22 May 2024

ADDENDUM NO. 1

**SCOTTS VALLEY WATER DISTRICT
SCOTTS VALLEY TRANSIT CENTER
LOW IMPACT DEVELOPMENT (LID) RETROFIT PROJECT – PHASE 2**

SCALE: 1"=10'-0"
JOB NO: 2468009.00
DATE: MAY 2024
SHEET 23 OF 27
L3.0

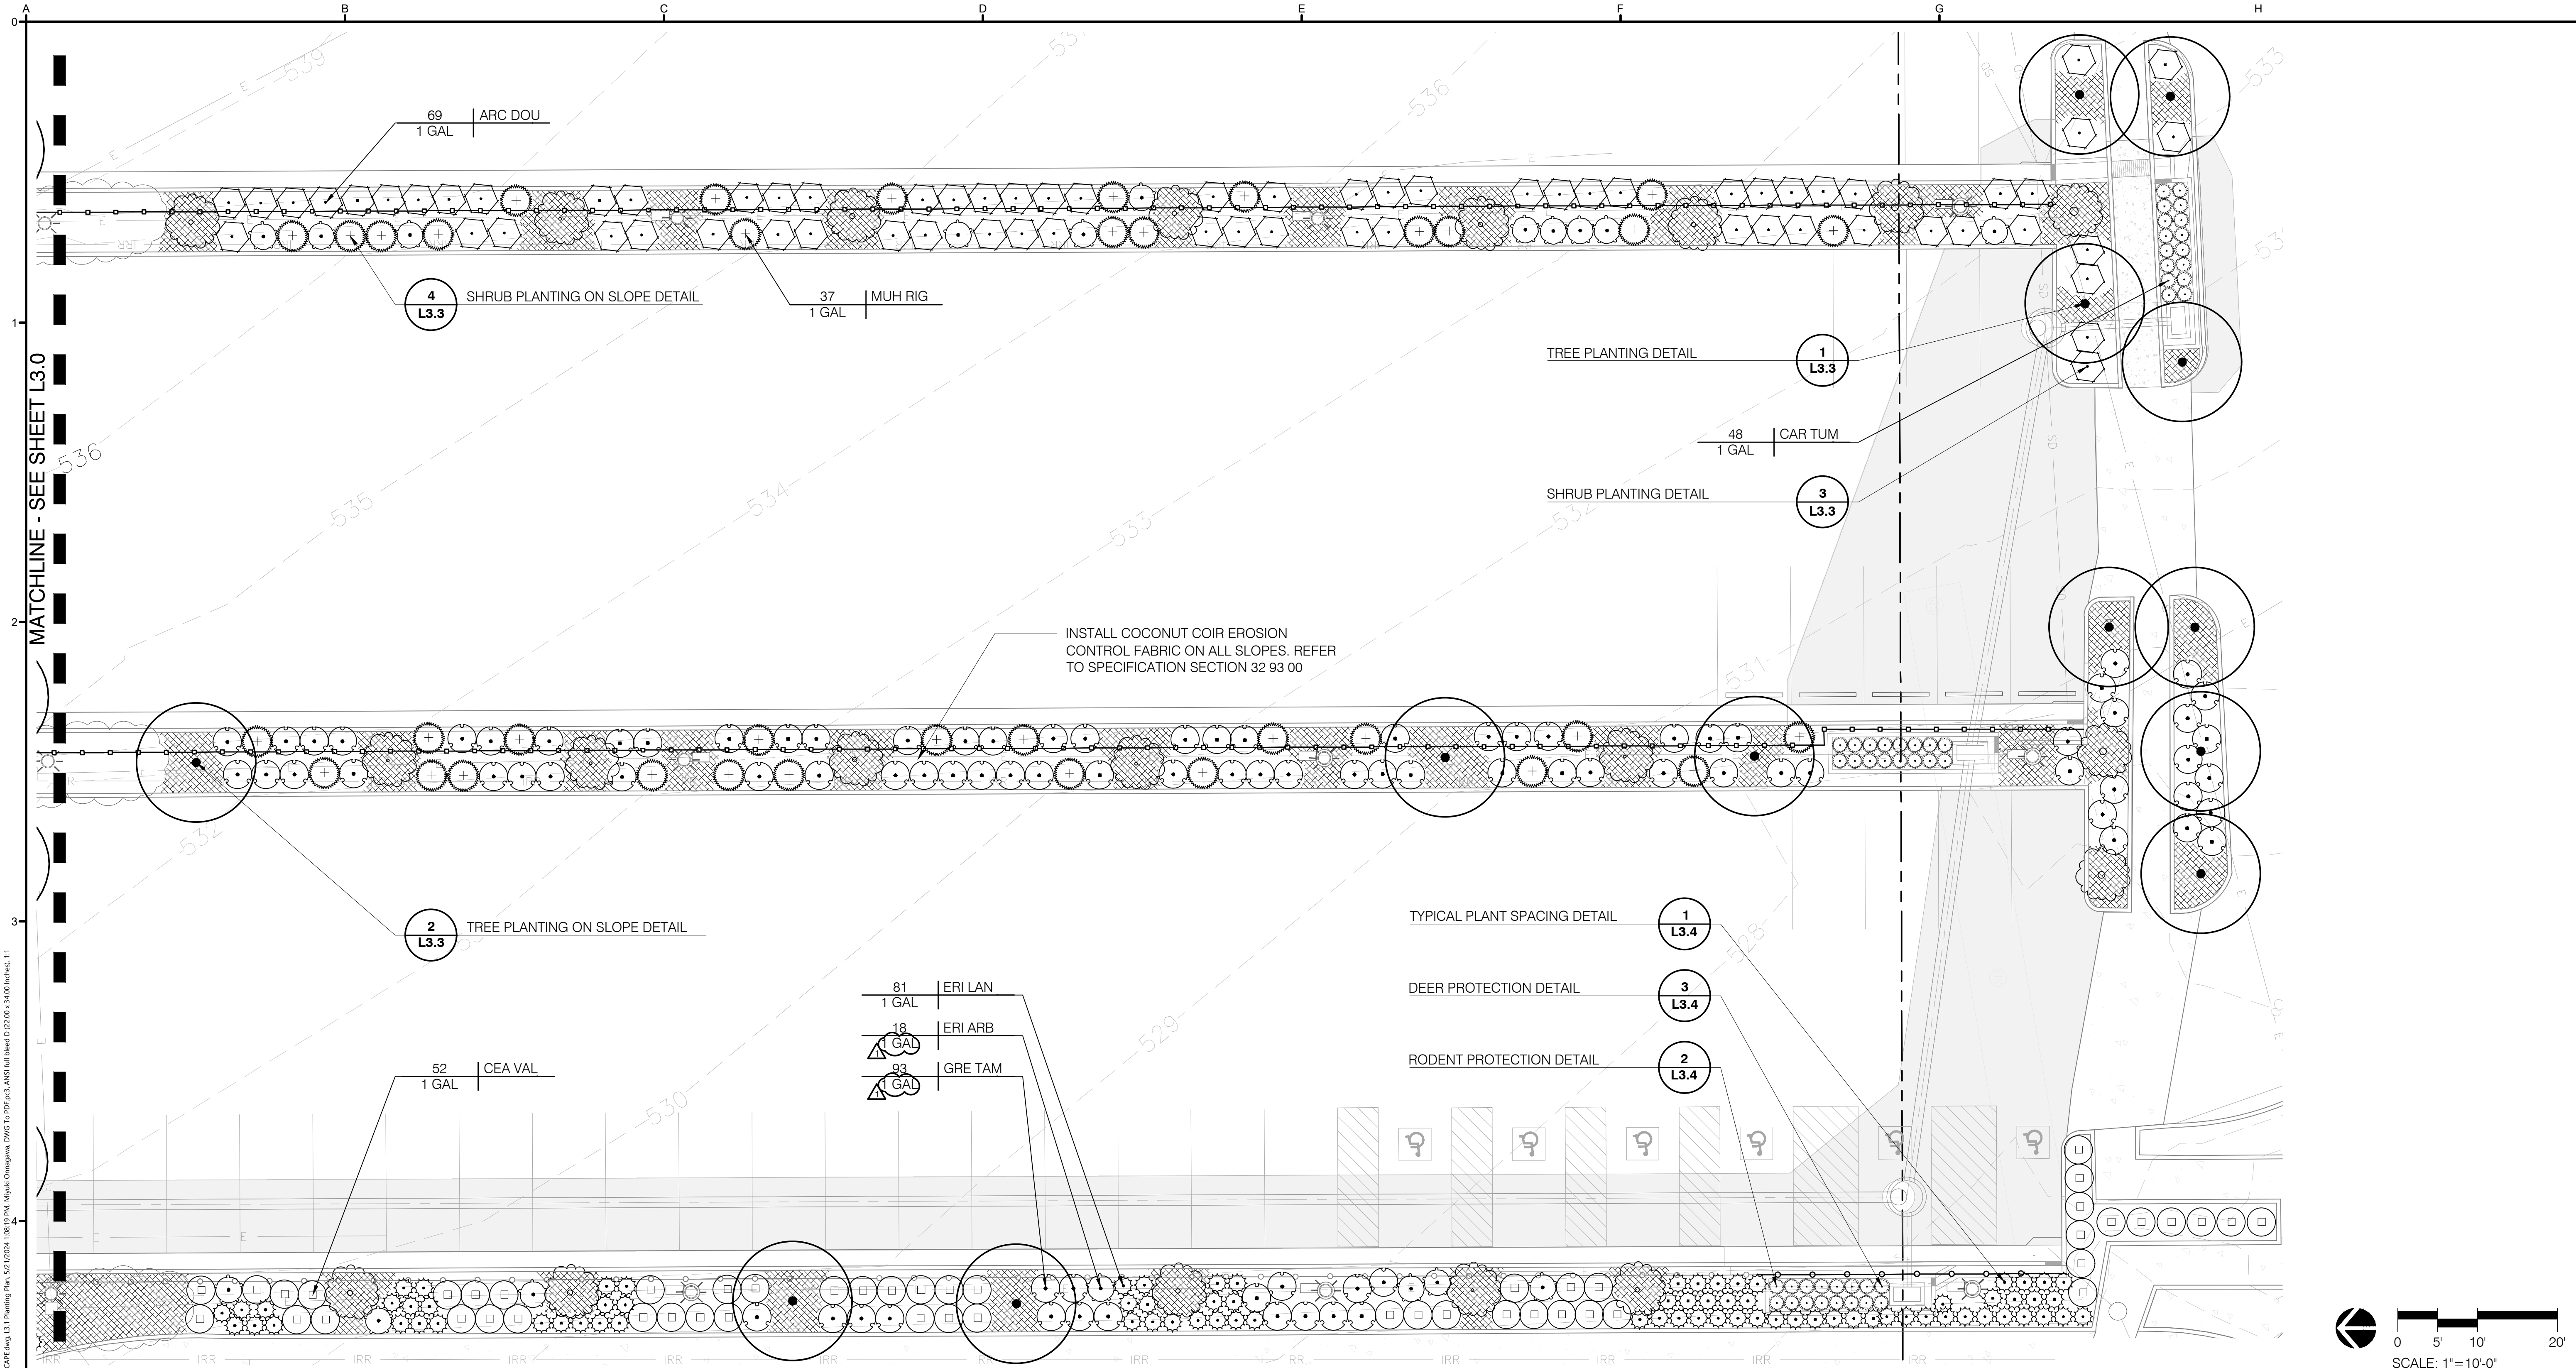
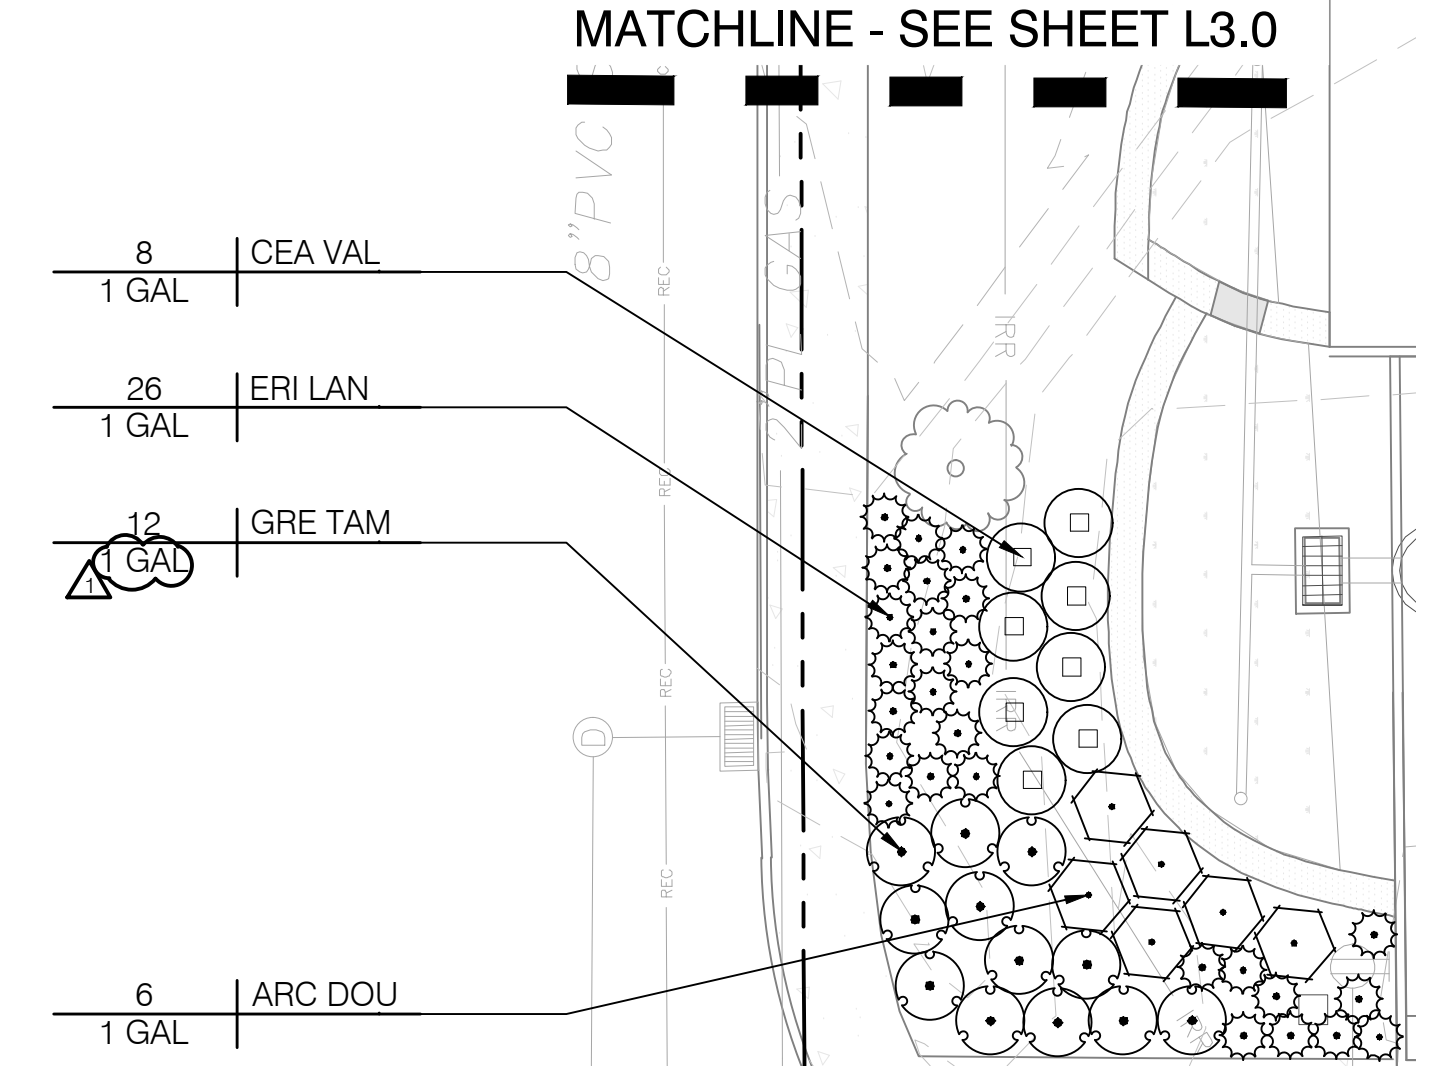
1.06	Sheet L3.0	DELETE Sheet L3.0 in its entirety and in its place ADD attached Sheet L3.0 that includes delta-1 dated 05/2024 in its revision block. Revisions generally include edits to the plant container sizes.

L3.1

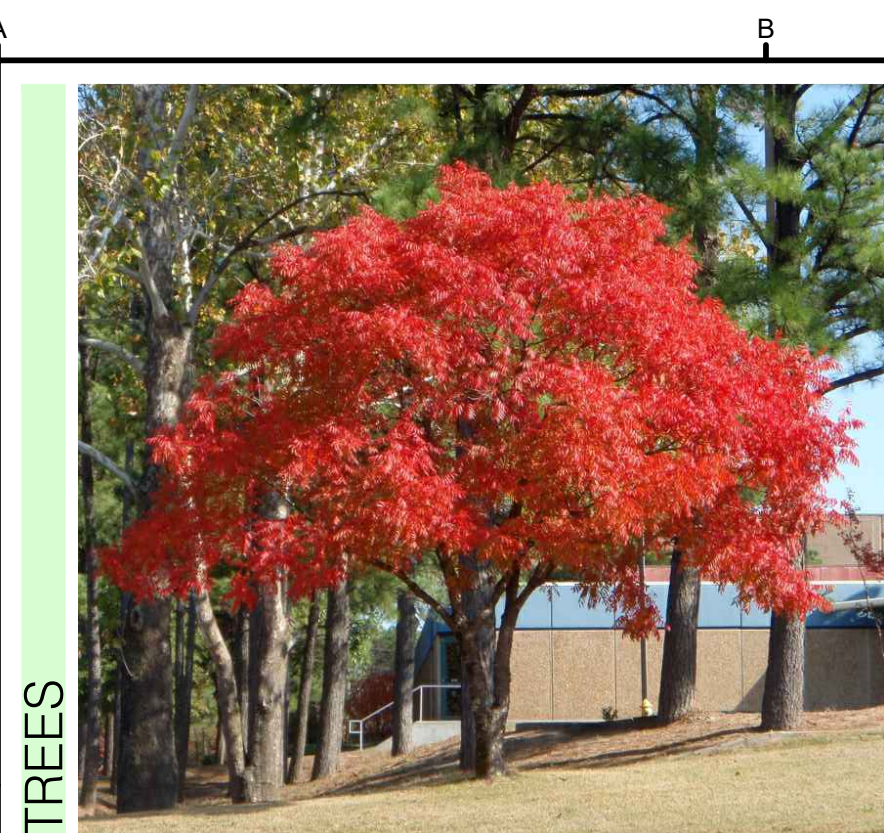
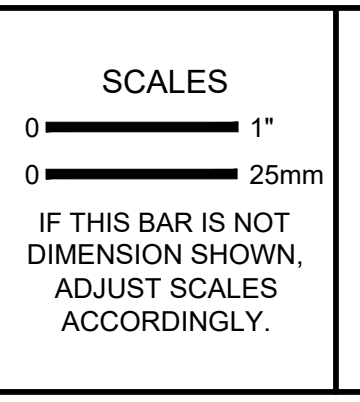
1.07	Sheet L3.1	DELETE Sheet L3.1 in its entirety and in its place ADD attached Sheet L3.1 that includes delta-1 dated 05/2024 in its revision block. Revisions generally include edits to the plant container sizes.
